Comments Received For Revisions to
Chapter 7 Section 7.1

Comment Period Closed

November 26, 2018

Figure 1: Circular End of a Horizontal Storage Tank

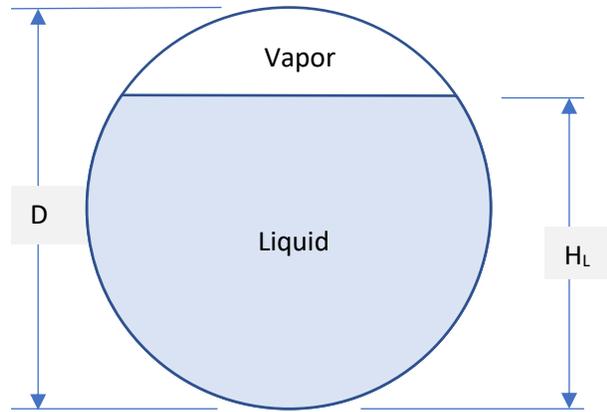
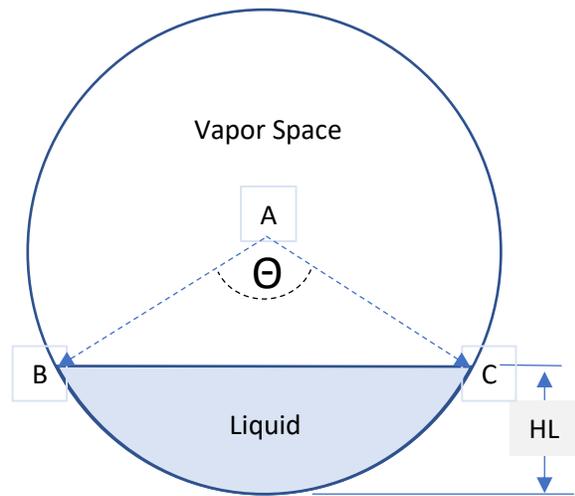
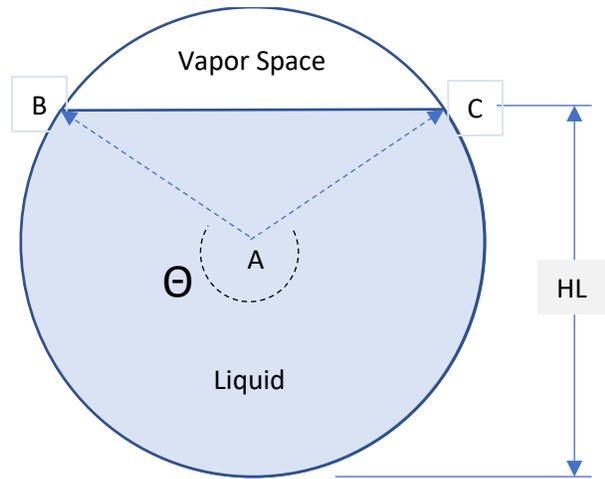
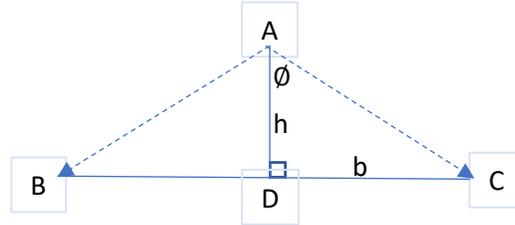
The methodology proposed in this section provides a much more accurate approach for calculating V_V and H_{VO} for a horizontal fixed roof tank than the approach described in the proposed rule. Figure 1 is a diagram of the circular end of a horizontal storage tank with diameter D and liquid height H_L. The length of the horizontal storage tank L is not shown.

The methodology proposed in this document provides a much more accurate approach for calculating V_v and H_{v0} for a horizontal fixed roof tank than the approach described in the proposed rule. Figure 1 is a diagram of the circular end of a horizontal storage tank with diameter D and liquid height H_L . The length L of the horizontal storage tank is not shown.

Figure 2 shows the circular end of a horizontal storage tank where the liquid height (H_L) is approximately 25% of the available height (or diameter) of the shell. The surface of the liquid intercepts the shell at points A and C. A circular sector is created by two line segments with length R that extend from the center at point A to intercept the shell at points B and C. The area of the circular sector A_s is proportional to the ratio between θ and the total number or radians in the circle (2π). Therefore, if θ is known, then the area of the circular sector A_s calculated using Eq-6.

Figure 3 shows the circular end of a horizontal storage tank where the liquid height (H_L) is approximately 75% of the available vessel height of the shell. In this example, the circular sector is the shaded portion of the circle that is below the liquid surface and excludes the area A_T of the triangular section created by points A, B, and C. Assuming that θ is known, then the area A_S in Figure 3 may be calculated using Eq-6 as described earlier.

Note that if the liquid height is below the center of circular shell where H_L is lower than R (as seen in Figure 2), then the value for A_T is subtracted from the area of the circular sector. Alternatively, when the liquid height is above the center of the circular shell where H_L is greater than R (as seen in Figure 3), then the value for A_T is added to A_S .
